DEVELOPMENT REVIEW COMMITTEE (DRC) COMMENT REPORT

PROJECT NAME: Wright Dynasty

CASE NUMBER: UDP-S21022

REQUEST: Site Plan Level II Review: 24 Multi-Family Residential Units, 5,000 Square Feet Commercial Use with Affordable Housing Building Height Incentive to 65 Feet in the Northwest Regional Activity Center

Principles of Street Design

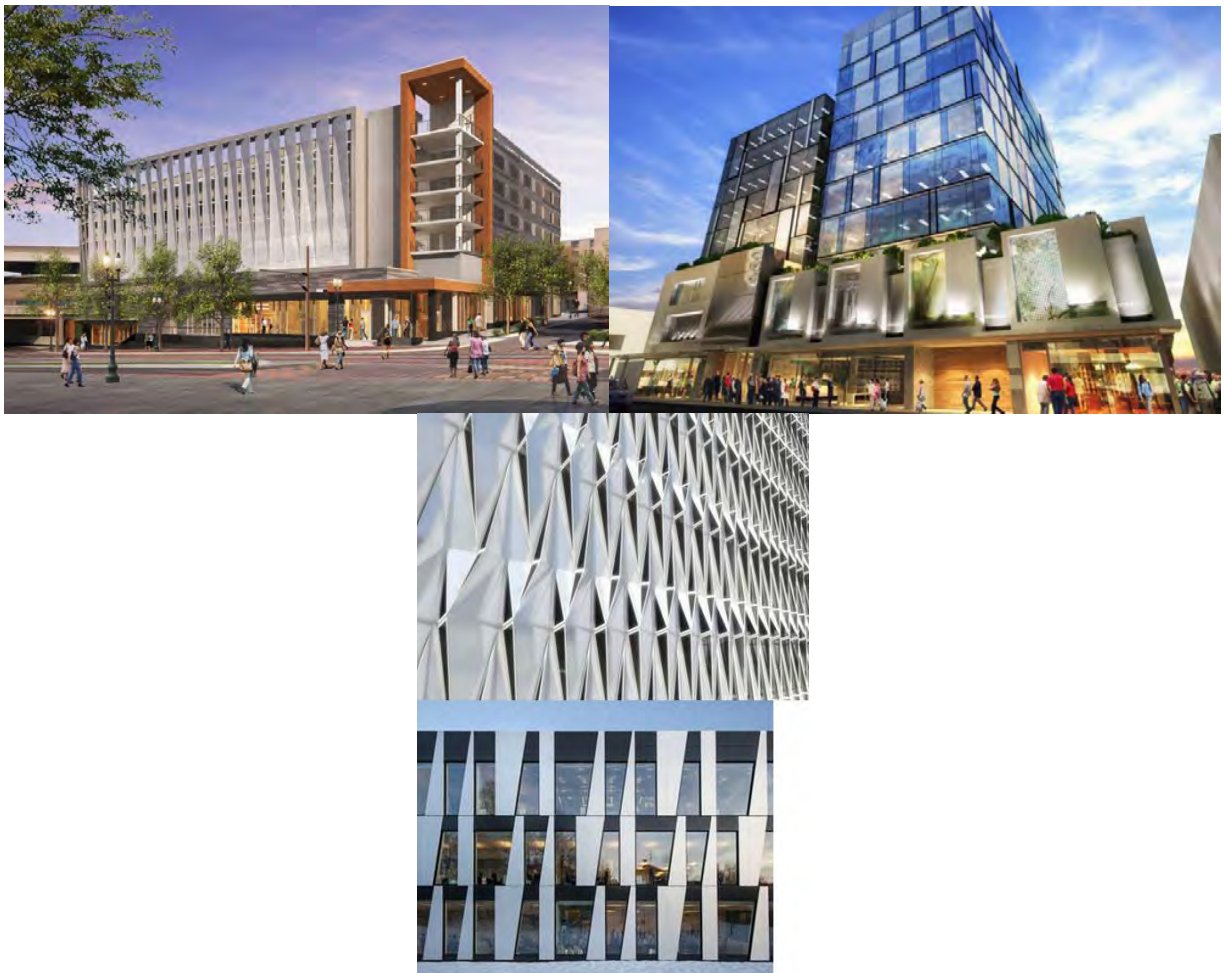
- a. Provide street cross-section and adjust the streetscape design to reflect the cross section for Primary Street - Sistrunk Boulevard with the following elements: travel lane, on-street parking, street trees, and 10-foot, 6 inches clear sidewalk. On-street parking and street trees shall not be aligned in the same streetscape element location. Provide dimensions on site plan;
- b. Street trees are exceeding the maximum spacing between trees and project is not maximizing street trees; see Landscape comments for more details.
- c. Provide information regarding the horizontal clearance between the face of the building and street trees;
